Addendum to the Water Quality Assessment Report (October 2015)

Centennial Corridor Project

Project ID: 0600000484
SCH ID: 2008091102

PURPOSE OF THE TECHNICAL MEMORANDUM

Attachment 1
Kaiser Realignment

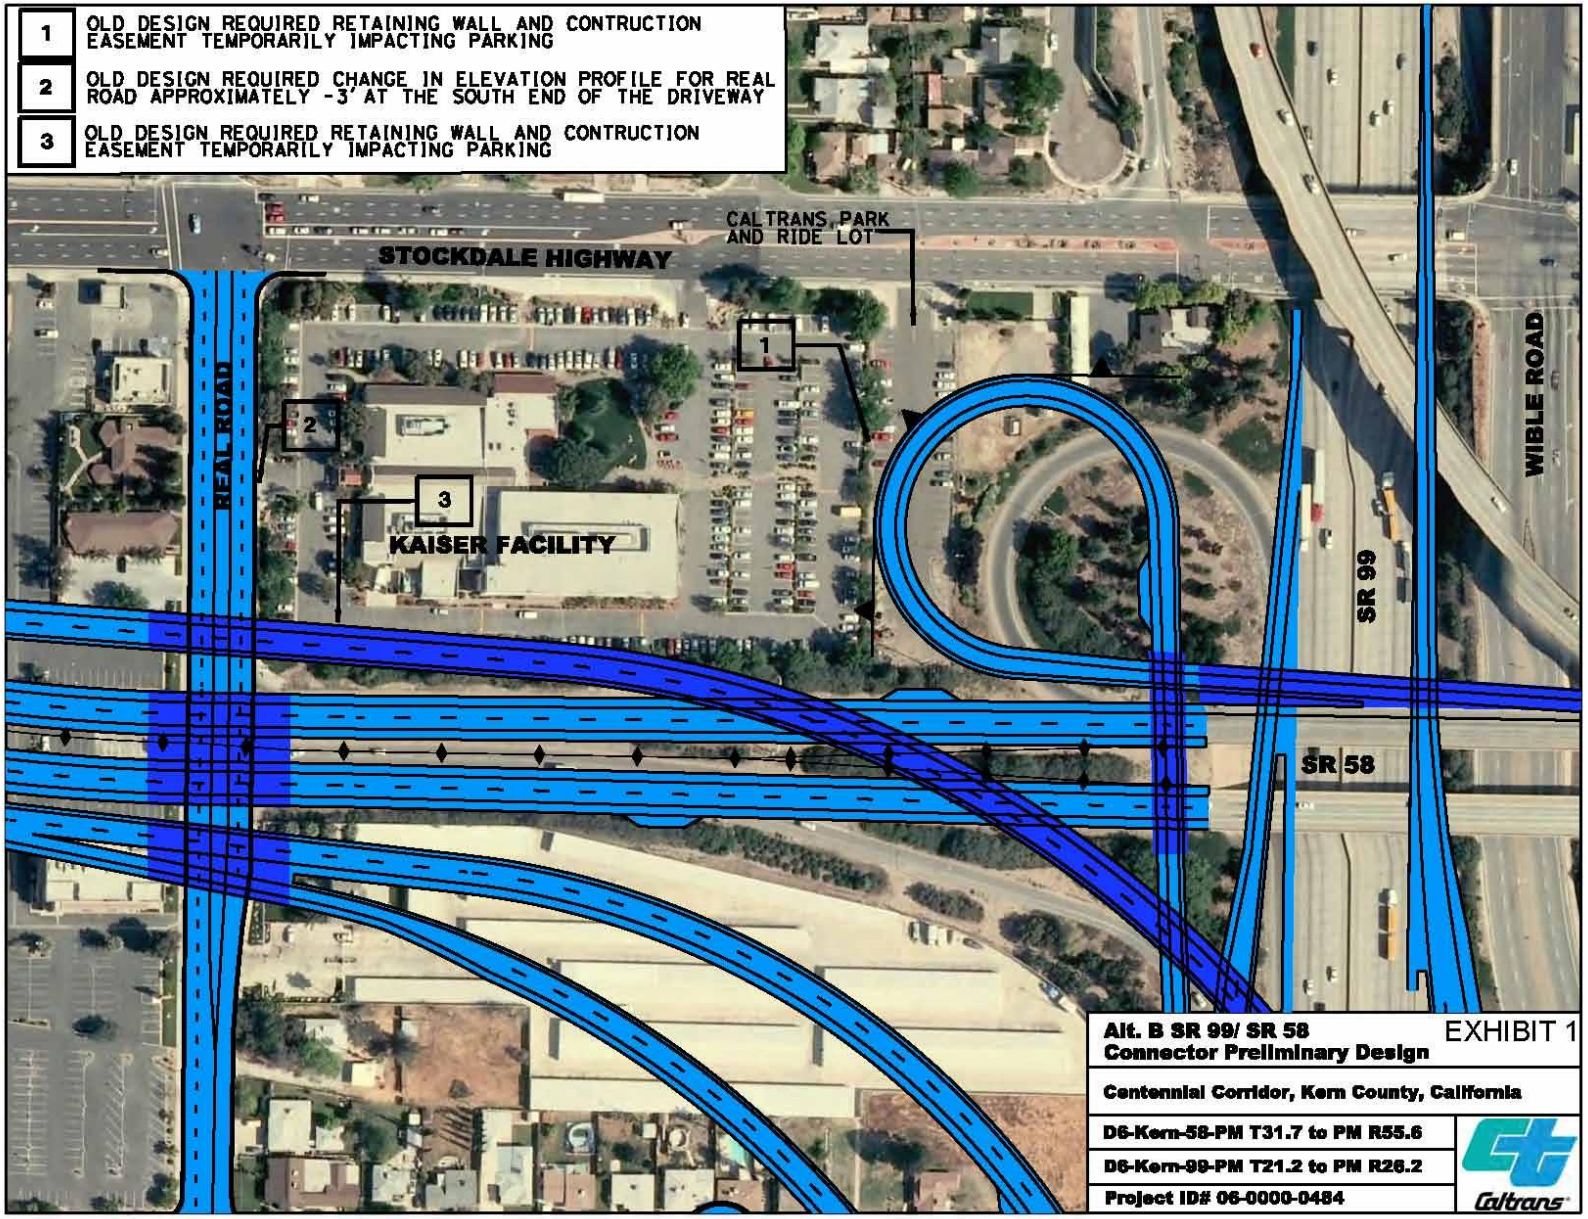
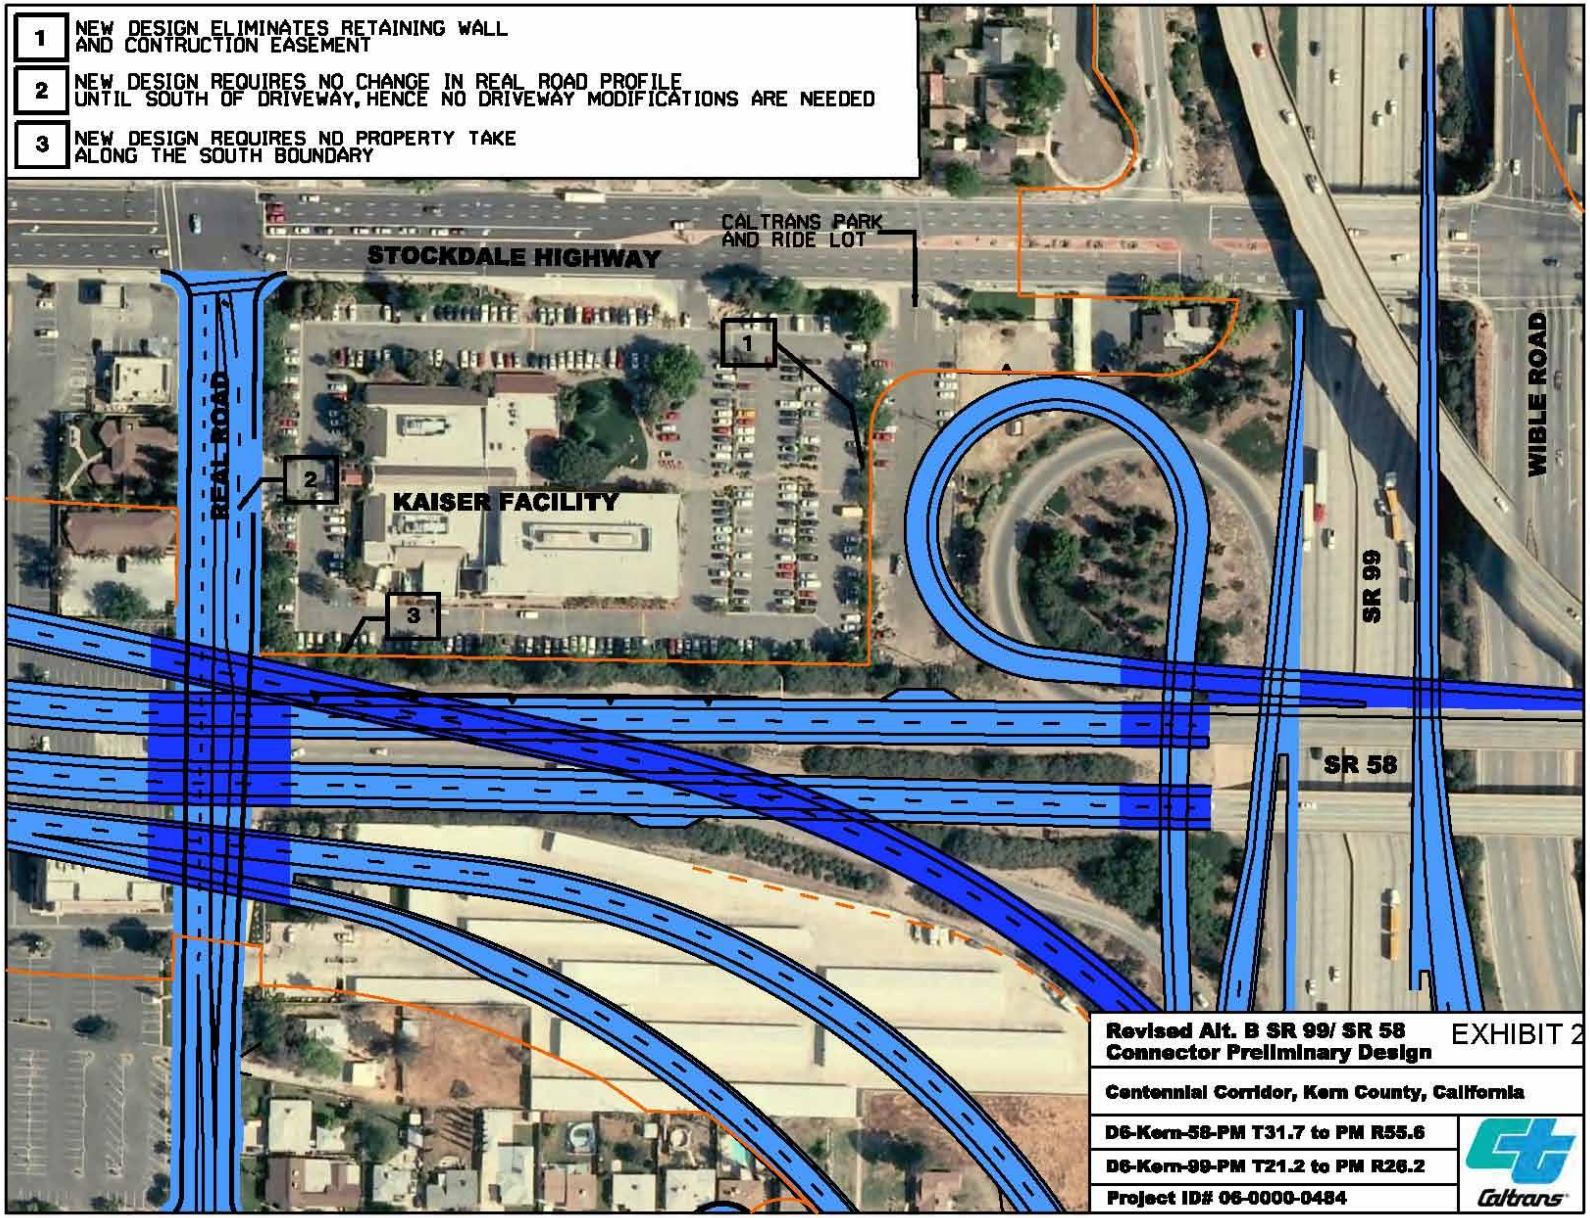
During the public circulation period of the draft environmental document, Caltrans and the city of Bakersfield received a letter on behalf of Kaiser Foundation Health Plan, Inc. (Kaiser), dated July 7, 2014, describing various concerns in regard to the proposed Centennial Corridor Project. Due to these concerns, preliminary design plans for Alternative B were modified to avoid direct impacts to the Kaiser Health Care Center. The preliminary design revisions that would avoid impacts on the Kaiser medical offices are depicted in Attachment 1 of this Addendum. These revisions would significantly increase the distances between the Kaiser facility and the project improvements, creating an 80-foot buffer between the medical facility's parking lot and the proposed alignment. No obstructions associated with the Centennial Corridor Project will block Kaiser Health Care Center driveways, and no modifications would be made to change the configuration of the existing driveways. In addition, the modified design will not require property or temporary construction easements on Kaiser's property.

1 OLD DESIGN REQUIRED RETAINING WALL AND CONTRUCTION EASEMENT TEMPORARILY IMPACTING PARKING
2 OLD DESIGN REQUIRED CHANGE IN ELEVATION PROFILE FOR REAL ROAD APPROXIMATELY -3' AT THE SOUTH END OF THE DRIVEWAY
3 OLD DESIGN REQUIRED RETAINING WALL AND CONTRUCTION EASEMENT TEMPORARILY IMPACTING PARKING
CALTRANS PARK AND RIDE LOT
STOCKDALE HIGHWAY
REAL ROAD
KAISER FACILITY
SR 99
SR 58
WIBLE ROAD
Alt. B SR 99/ SR 58 Connector Preliminary Design
EXHIBIT 1
Centennial Corridor, Kern County, California
D6-Kern-58-PM T31.7 to PM R55.6
D6-Kern-99-PM T21.2 to PM R26.2
Project ID# 06-0000-0484
Caltrans

1 NEW DESIGN ELIMINATES RETAINING WALL AND CONTRUCTION EASEMENT
2 NEW DESIGN REQUIRES NO CHANGE IN REAL ROAD PROFILE UNTIL SOUTH OF DRIVEWAY, HENCE NO DRIVEWAY MODIFICATIONS ARE NEEDED
3 NEW DESIGN REQUIRES NO PROPERTY TAKE ALONG THE SOUTH BOUNDARY
CALTRANS PARK AND RIDE LOT
STOCKDALE HIGHWAY
REAL ROAD
KAISER FACILITY
SR 99
SR 58
WIBLE ROAD
Revised Alt. B SR 99/ SR 58 Connector Preliminary Design
EXHIBIT 2
Centennial Corridor, Kern County, California
D6-Kern-58-PM T31.7 to PM R55.6
D6-Kern-99-PM T21.2 to PM R26.2
Project ID# 06-0000-0484
Caltrans

Attachment 2
Carrier Canal Crossing Design Modification

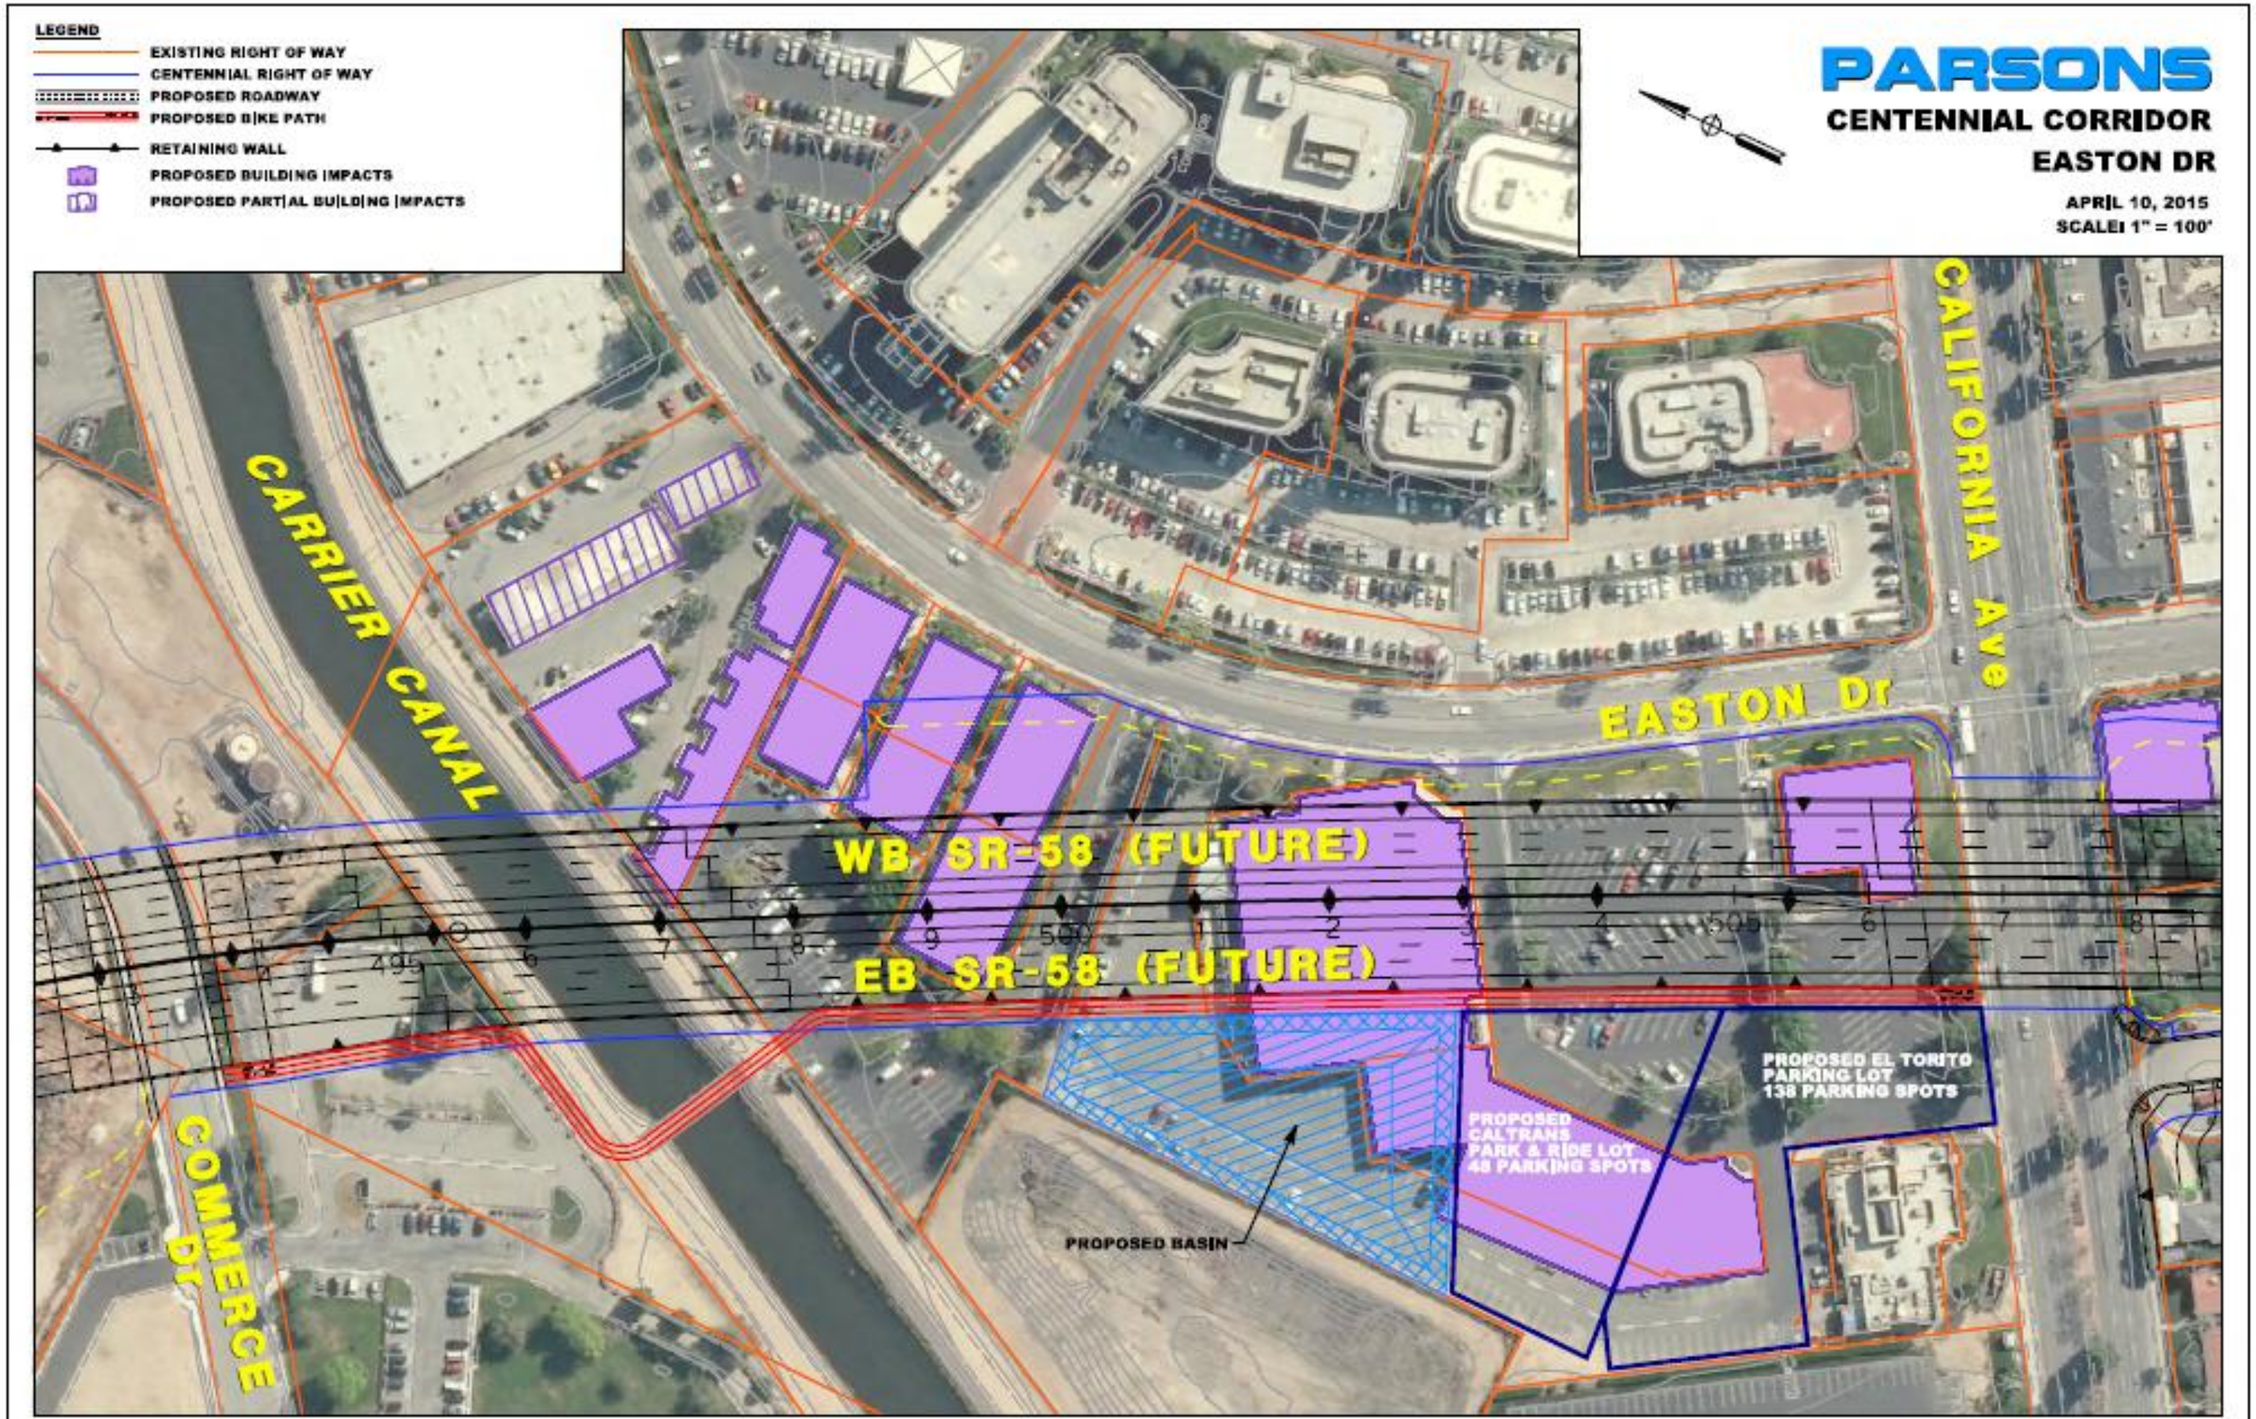
To address concerns regarding bicycle and pedestrian connectivity, preliminary design plans for Alternative B were revised to include a multi-use pathway that will run parallel to the project alignment connecting bicyclists and pedestrians from California Avenue to Commerce Drive. The decision to incorporate a multi-use pathway to accommodate a bicycle and pedestrian connection was made in response to public comments requesting a bicycle connection spanning over the Carrier Canal. As part of this change, an approximately 100-foot-long-bridge over the Carrier Canal would be constructed to accommodate bicycles and pedestrians. The bridge would be of sufficient width to accommodate two-way pedestrian and bicycle traffic. The preliminary design layout for the Carrier Canal Crossing is included in Attachment 2 of this Addendum. The proposed modification is located within the study area analyzed in the draft environmental document and supporting technical studies. This multi-use pathway and bridge structure will provide direct connectivity to the Kern River Parkway Bike Trail for its users.

Attachment 3
Joseph Drive Pedestrian Crossing

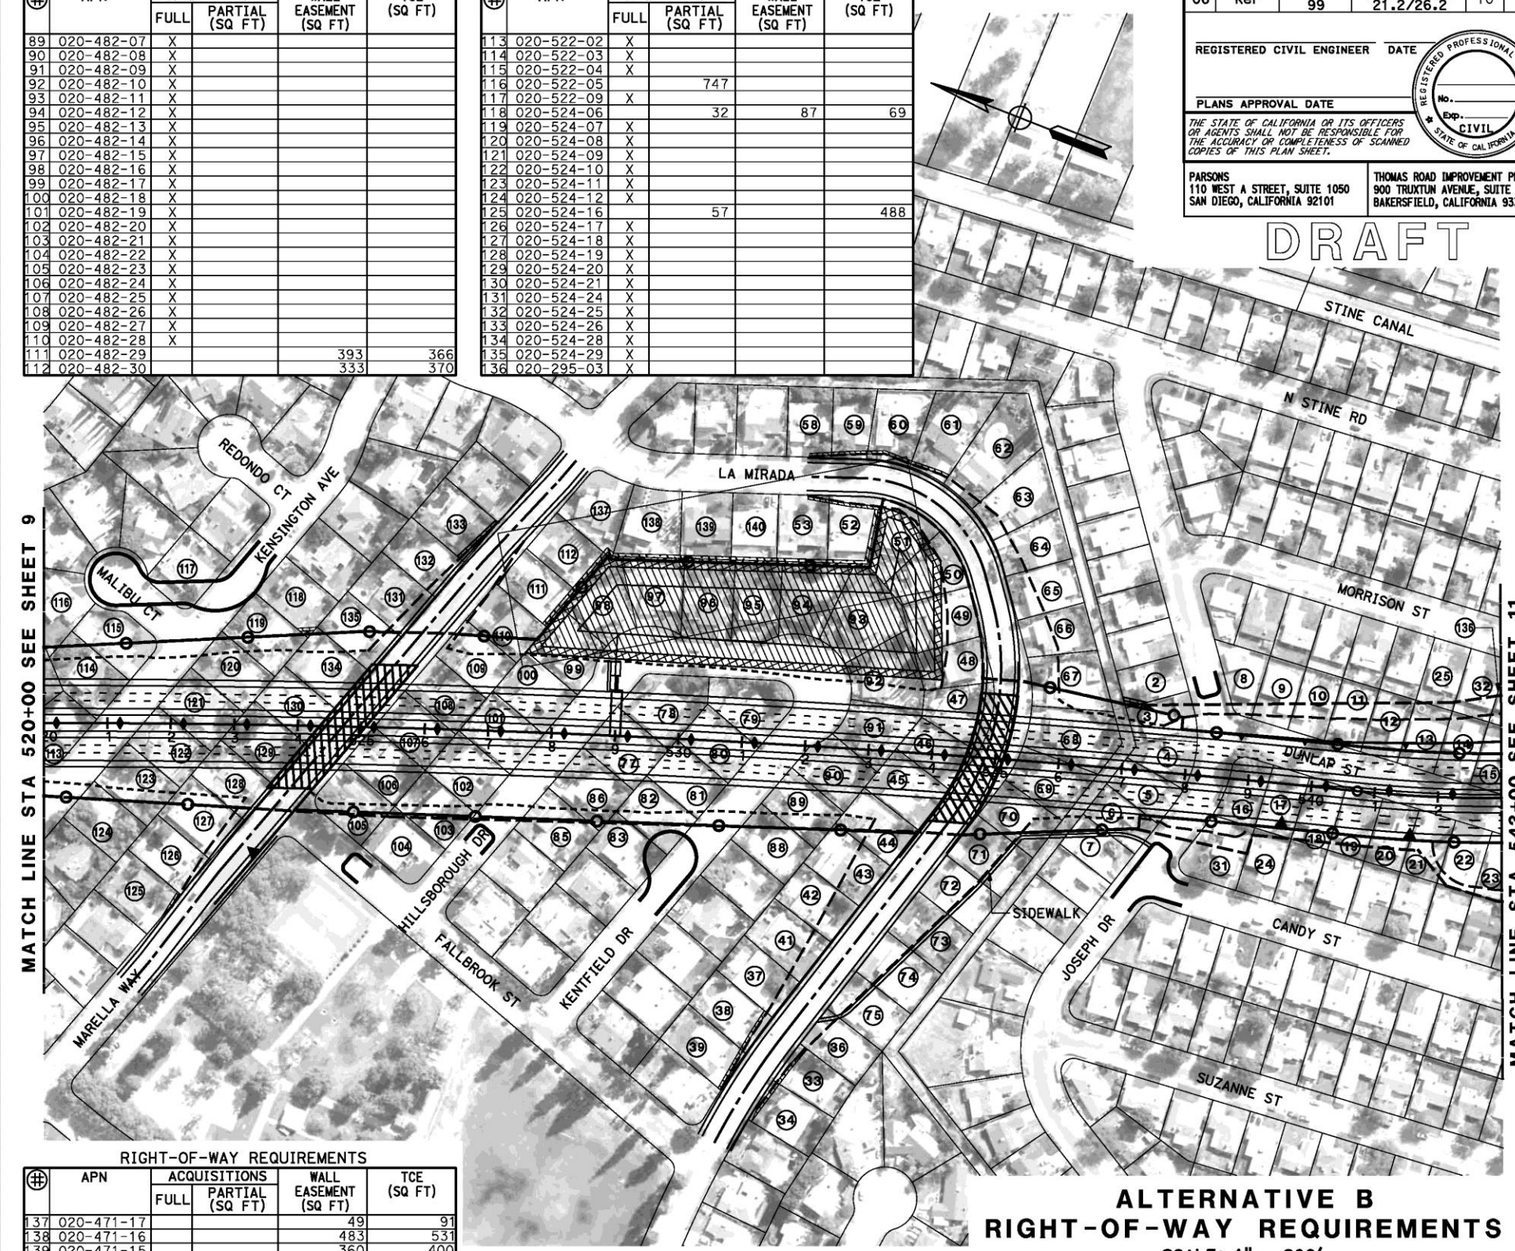
Implementation of the Centennial Corridor Project will result in the permanent closure of 11 local streets, which in some cases greatly lengthens the routes for current pedestrian routes in the Westpark neighborhood. The city will coordinate with Caltrans to install a dedicated new pedestrian sidewalk for the benefit of residents living in homes south of La Mirada Drive and Joseph Drive. The pedestrian sidewalk would enhance connectivity to newly divided areas in the Westpark neighborhood and shorten the route for pedestrians to access popular community facilities located on either side of the freeway, including Centennial Park, Harris Elementary school, and other neighborhood destinations. This proposed feature would upgrade bicyclist and pedestrian access via La Mirada Drive. The preliminary design layout for the Joseph Drive pedestrian crosswalk is included in Attachment 3 of this Addendum.
